**SPECIFIC AGENDA WORDING: Consideration of Halff Engineering Flood Study Review No. 1, 2, and 3 and approval of road cut to be made in accord with such study to accommodate box culverts and drainage under County Road 805 from Villages of Mayfield Phase I in City of Cleburne in Johnson County, Texas.**

**Re: Villages of Mayfield Phase 1 – Flood Study Review #1**

**Re: Villages of Mayfield Phase 1 – Flood Study Review #2**

**Re: Villages of Mayfield Phase 1 – Flood Study Review #3**

C-4.3

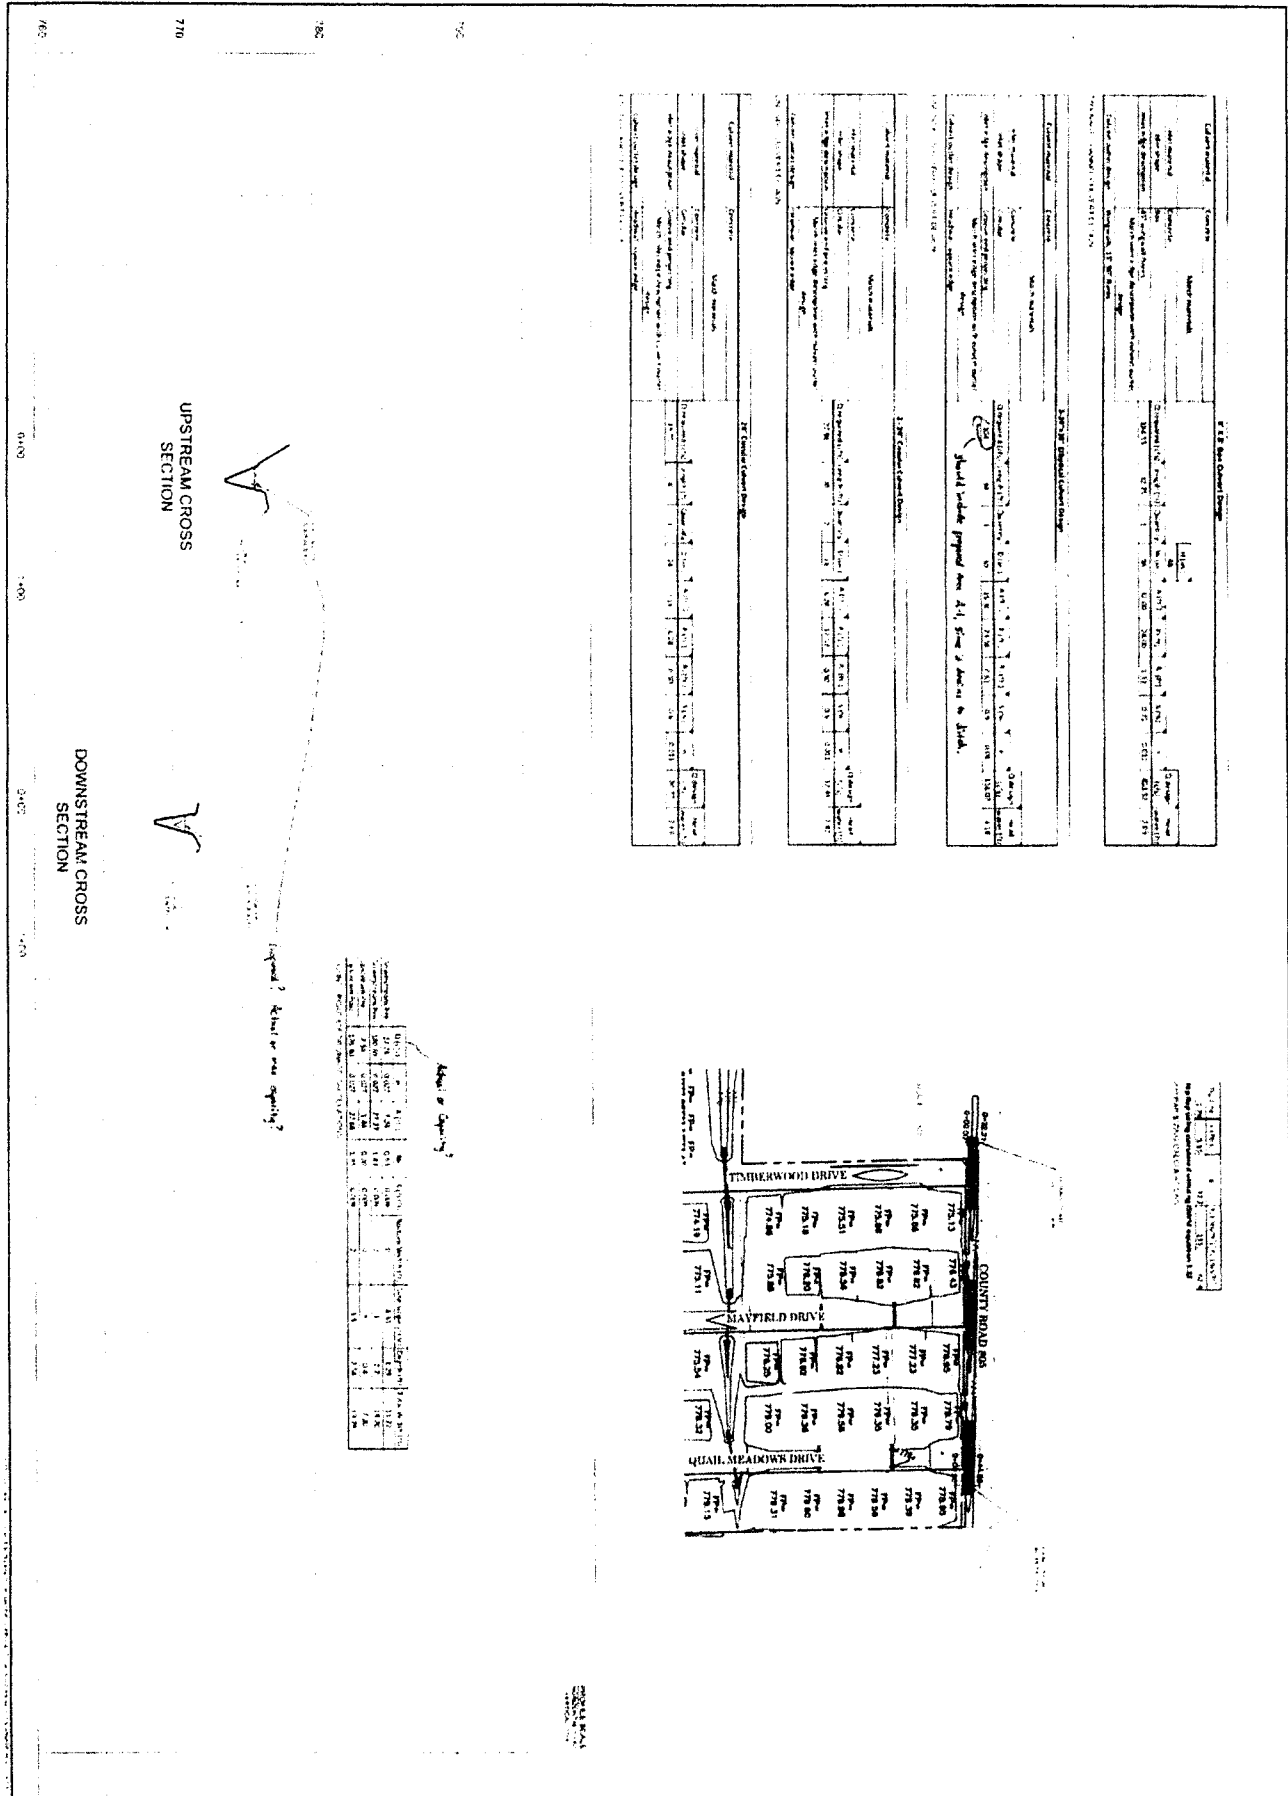
10/24/19 Halff: The cross section hydraulic calculations shown on Sheets C-4.3 and C-4.6 do not consistently show the following information. See attached markups.

- a. Depth
- b. Storm frequency or whether it is a capacity calculation.
- c. N-values (different values shown for upstream ditch cross section on Sheets C-4.3 and C-4.6
- d. Slopes (different values shown for upstream ditch cross section)

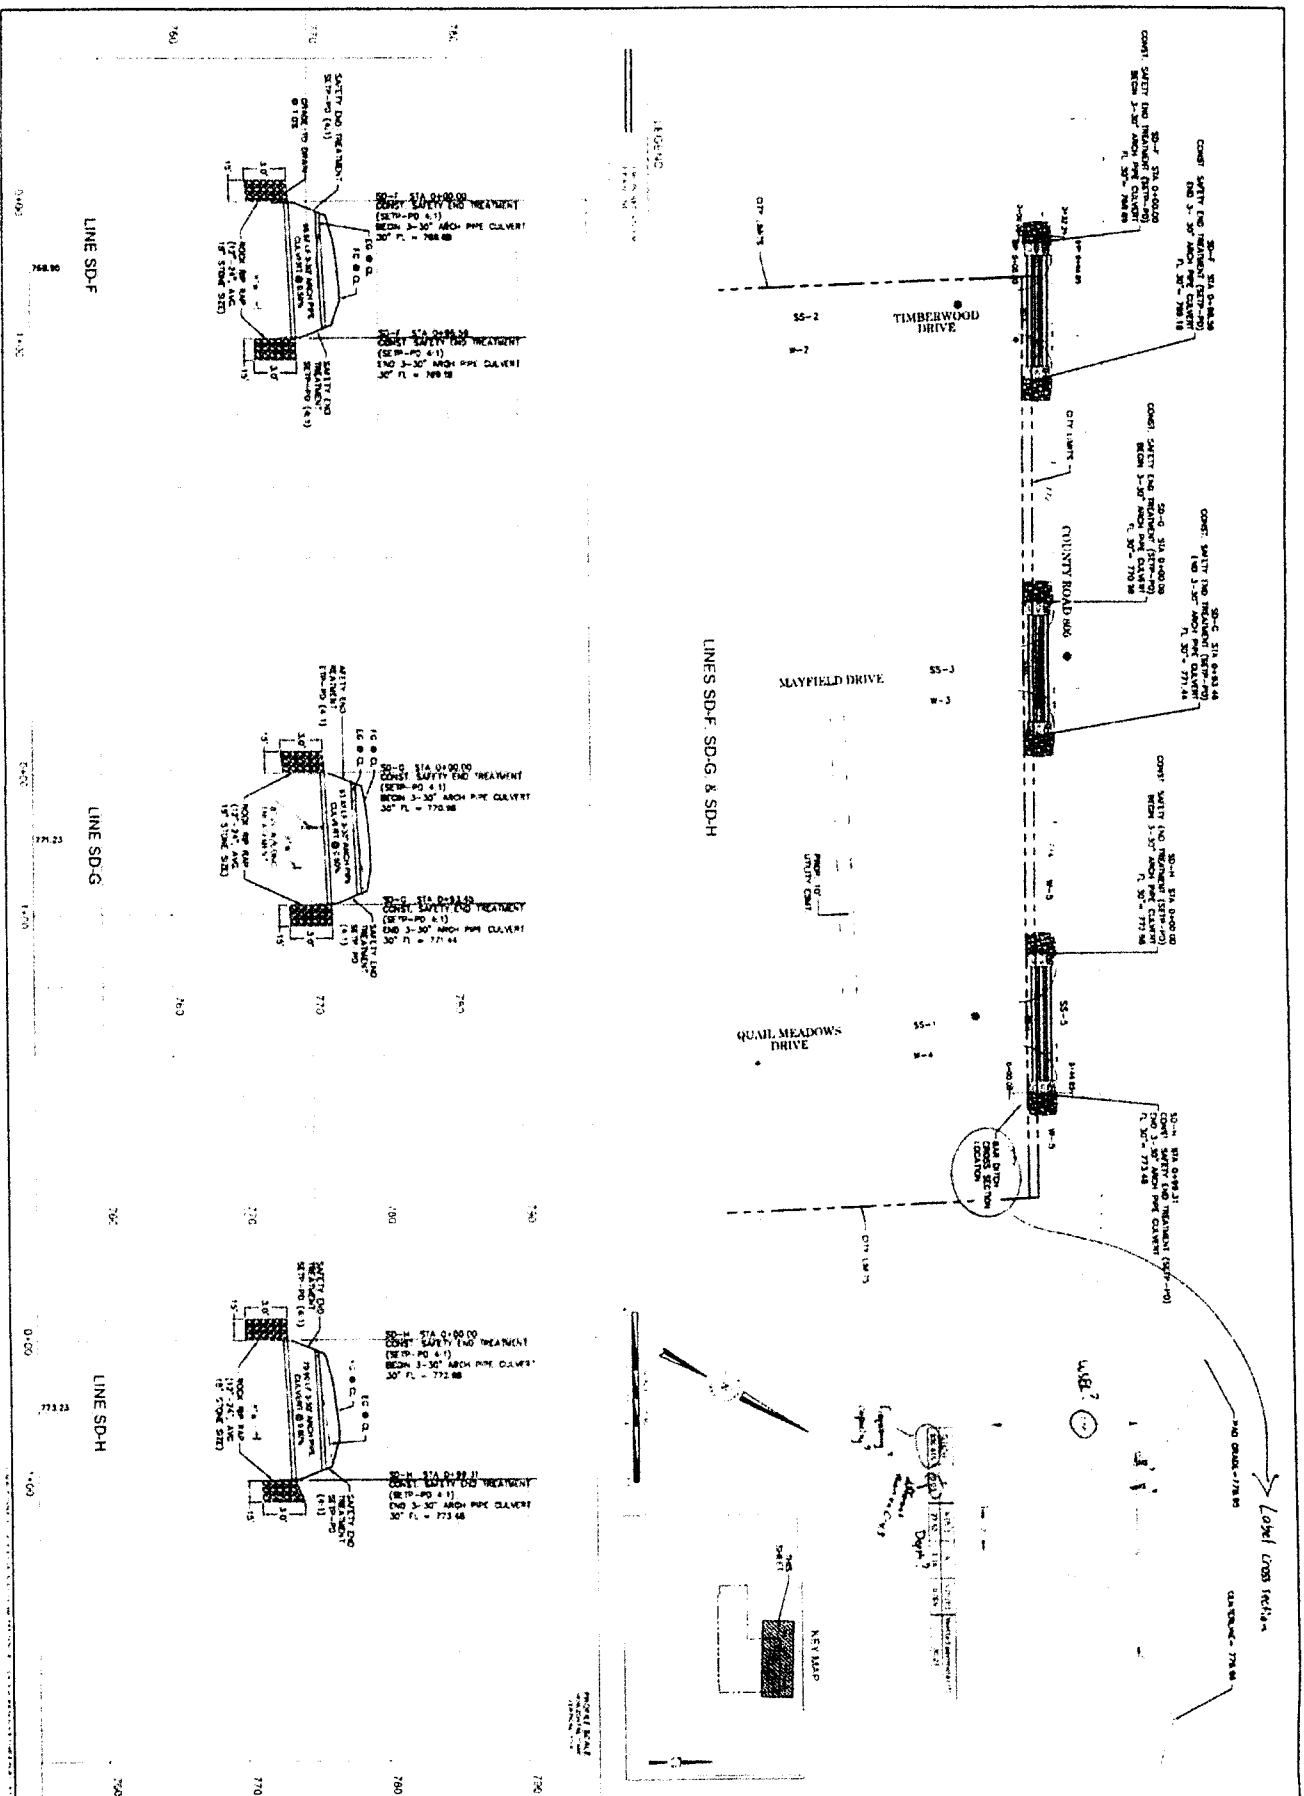
Please check and reconcile all inputs and results, ensuring they match and that they correspond to the discharges calculated for OS-2 on sheets C-4.1 and C-4.2.

**C-4.7**

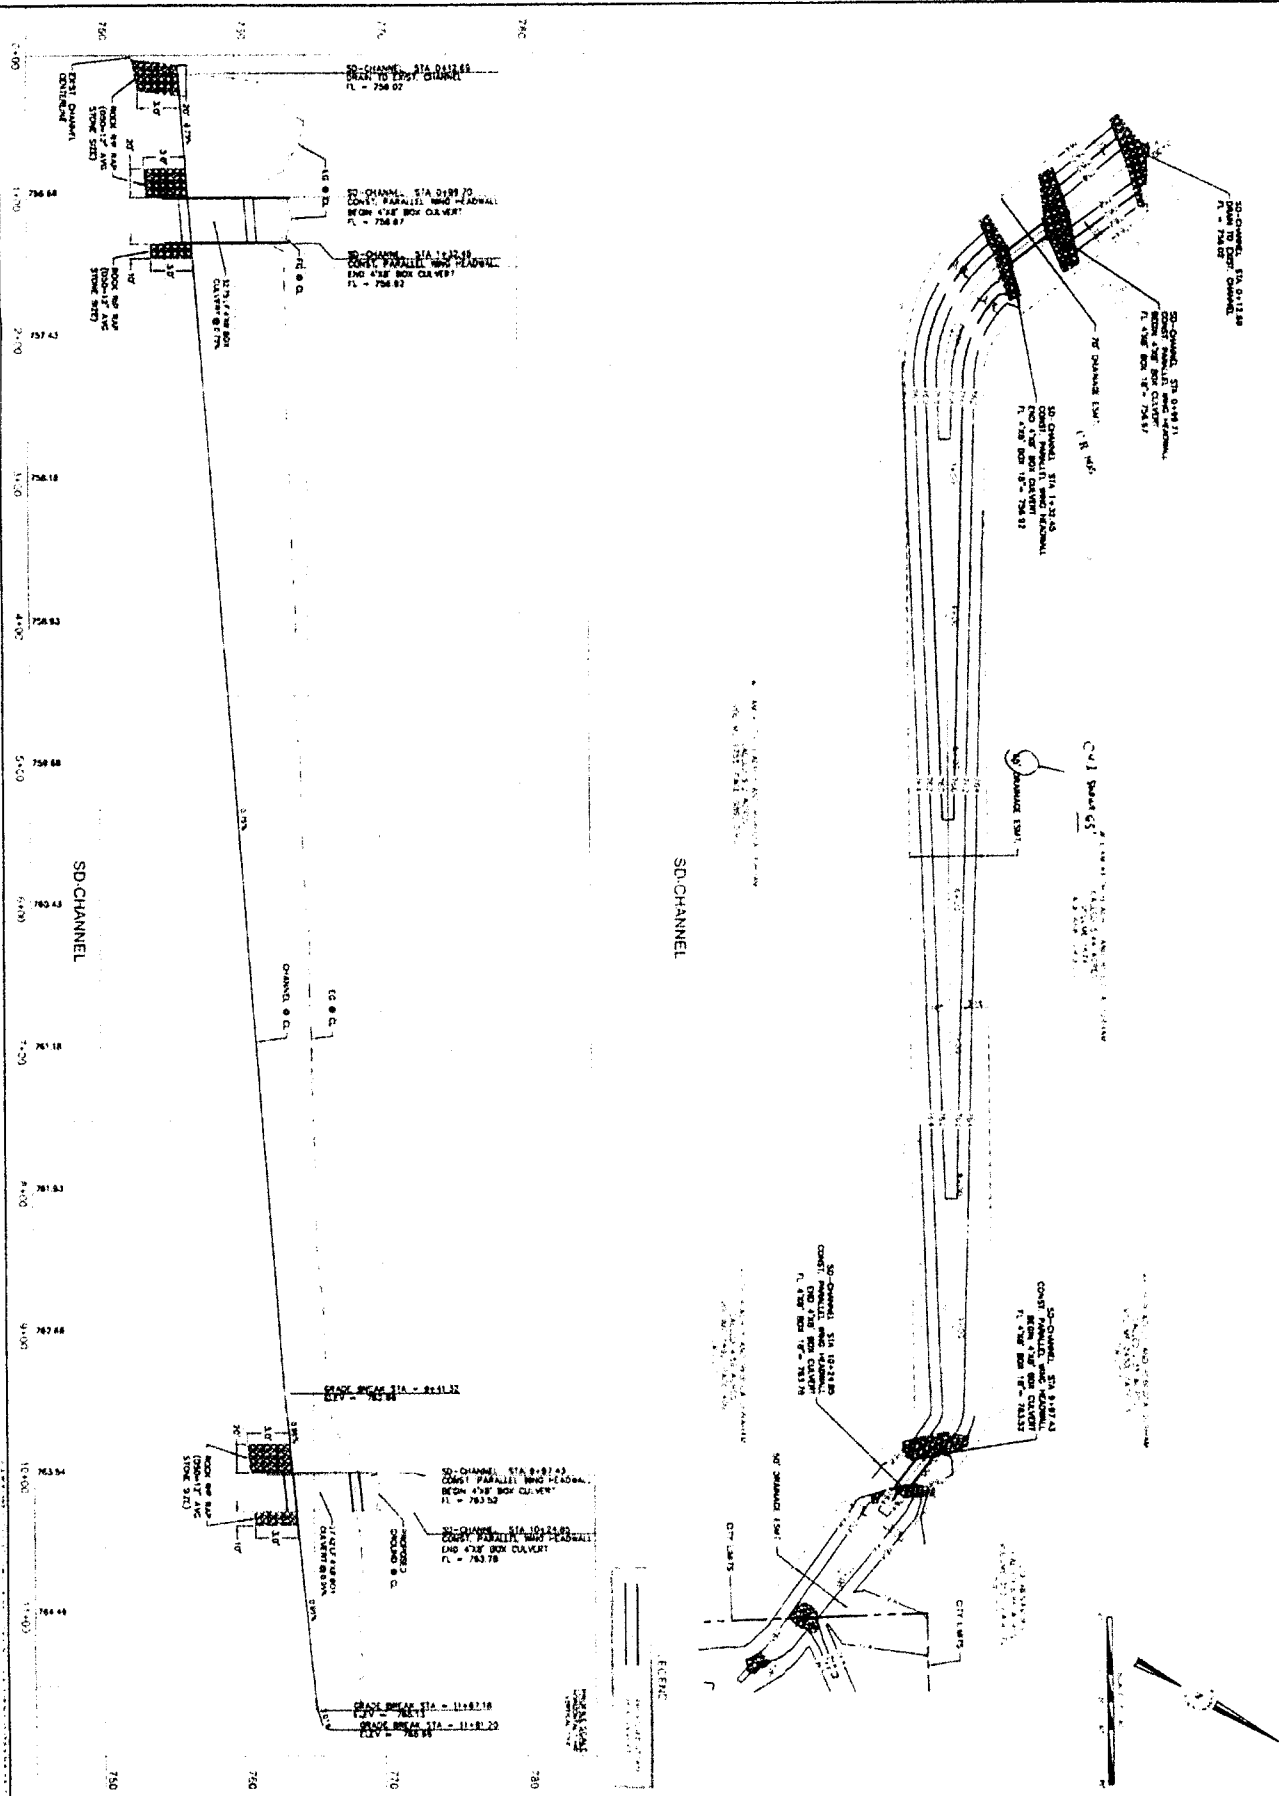
10/24/19 Halff: Acknowledged. Sheet C-4.7 shows a 55' width easement, whereas Sheet C-4.2 shows 65'. Please reconcile.
